Access Compliance Report

Public Rights-of-Way

(Curb Ramps)

Intersection ID: 14949	Main Street: CAMPBELL_DR	Cross Street: DRIFTWOOD_DR	Location: SE
ADA ID: 53A2A9A7E3B4	Ramp Type: PerpDiag	Initial Pass/Fail: Pass	Overall Compliance: No
Severity Score: 22.75			
Codes/Mitigation Info/Possible Solution		Field Measurements/Component Compliance

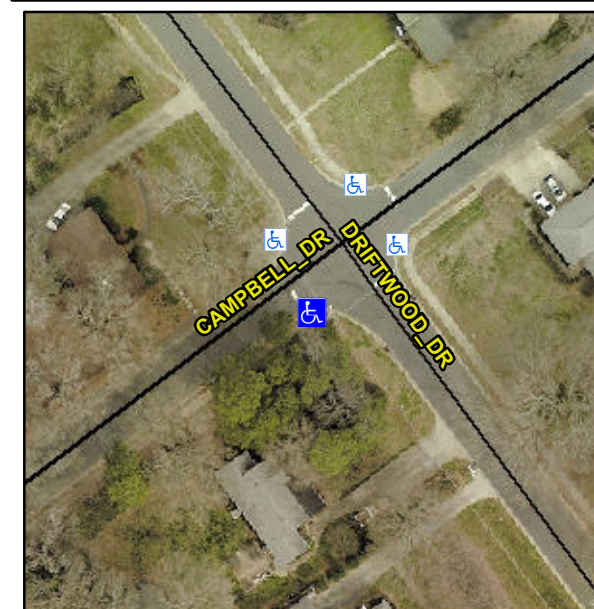
Not Found, R304.5.3, R304.2.1, R304.2.2-Perp, R304.3.2-Para, R302.7.2, R304.5.4

Compliance	Description	Data	Compliance	Description	Data
N/A	Ramp Length (in)	86.5	Yes	Ramp Slope (%)	5.6
Yes	Ramp Width (in)	66.0	No	Ramp XSlope (%)	4.2
N/A	Flare Type LT	Sloped	N/A	Flare Type RT	N/A
N/A	Flare Slope LT (%)	11.5	N/A	Flare Slope RT (%)	3.3
N/A	Flare Traversable LT?	No	N/A	Flare Traversable RT?	No
No	Landing Length (in)	N/A	Yes	DWS Provided?	Yes
No	Landing Width (in)	N/A	Yes	DWS Contrast?	Yes
No	Landing Slope (%)	N/A	Yes	DWS Length (in)	24.0
No	Landing X Slope (%)	N/A	Yes	DWS Full Width?	Yes
N/A	Landing Curb? (Y/N)	No	Yes	DWS Offset (in)	1.0
N/A	Shared Landing?	N/A			
Yes	Gutter Ponding?	No	No	Gutter Slope (%)	6.4
No	Gutter Lip Ht (in)	0.5	No	Gutter X Slope (%)	4.4
N/A	Painted X Walk1?	No	N/A	Painted X Walk2?	No
	X Walk 1 Direction	To NE		X Walk 2 Direction	To NW
N/A	X Walk 1 Width (in)	N/A	N/A	X Walk 2 Width (in)	N/A
	X Walk 1 Slope (%)	1.1		X Walk 2 Slope (%)	3.2
	X Walk 1 X Slope (%)	5.6		X Walk 2 X Slope (%)	0.6

N/A	Ramp inside XWalk1?	N/A	N/A	Ramp inside XWalk2?	N/A
	Road Slope (%)	2.5	N/A	Clear Space?	Yes
	Road X Slope (%)	2.0	N/A	Clear Space to XWalk (in)	N/A
Yes	Any Obstructions?	No	Yes	Storm Grate/Utility Hazard?	No
	Obstruction Type			Storm Grate/Utility Type	
		N/A			N/A
			Yes	Surface Condition? (G/P)	Good

Remove & Replace Curb Ramp With Two New Directional Ramps or Equivalent. Remove & Replace Gutter.
